ULNRC-1840

DOCKET NUMBER 50-483
CALLAWAY PLANT
WIDE RANGE GAS MONITOR
CONCENTRATION DISPLAY

Reference 1 requested a variance from the requirement as described in NUREG 0737, Section II.F.1, Attachment 1, Clarification 1. Reference 2 requested additional information concerning this variance request.

FIGURE 1

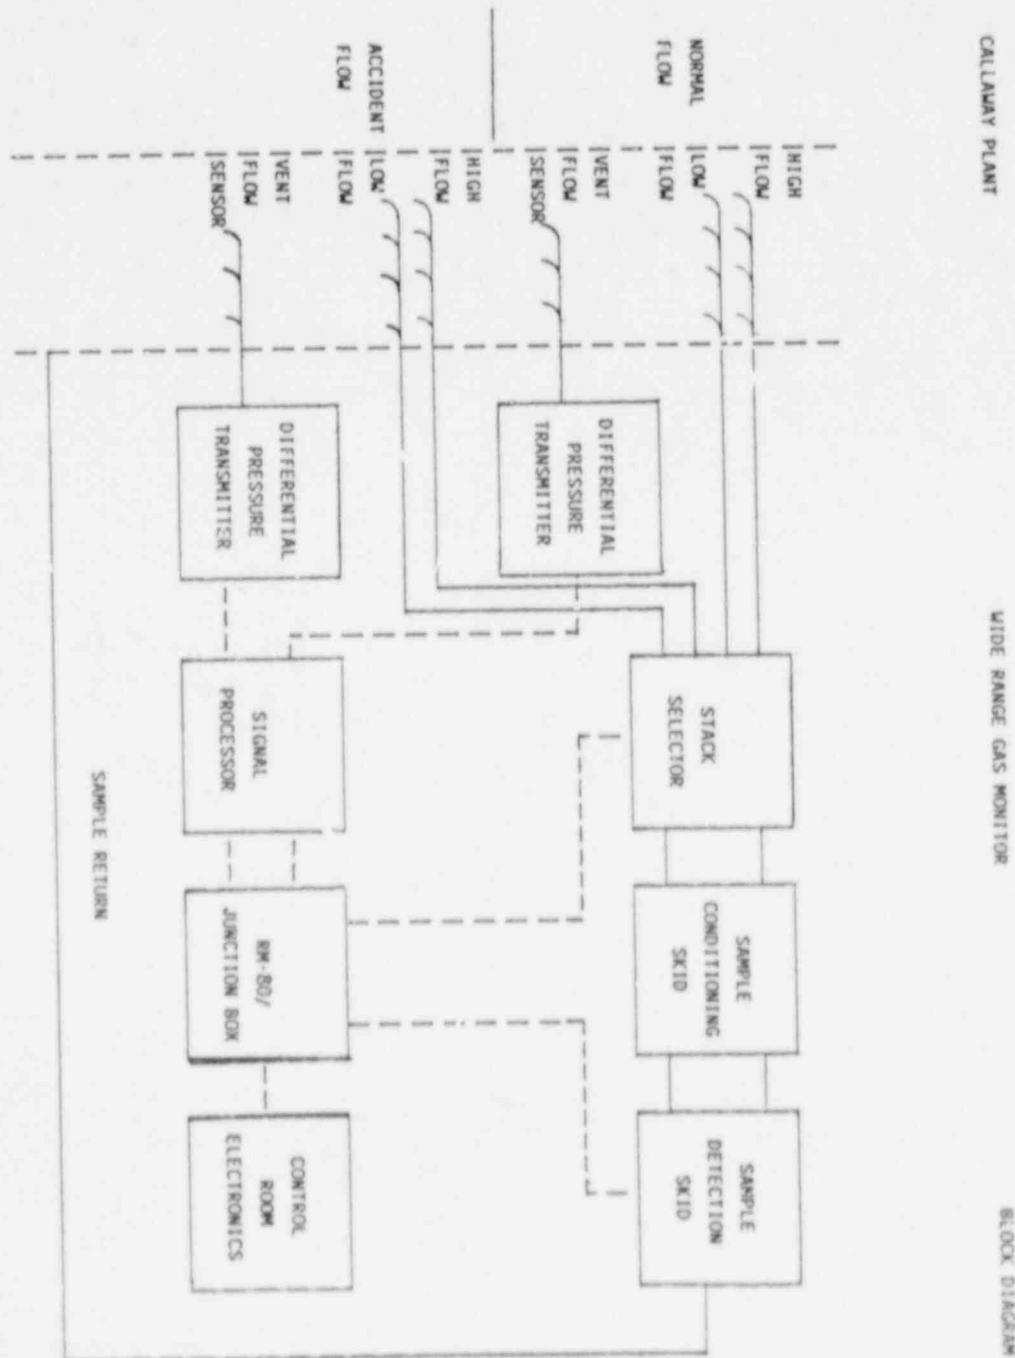
Item 1. Provide a block diagram of the General Atomic Wide Range Gas Monitor (WRGM).

Response: A block diagram of the Callaway Plant General Atomic Wide Range Gas Monitor is shown in Figure 1.
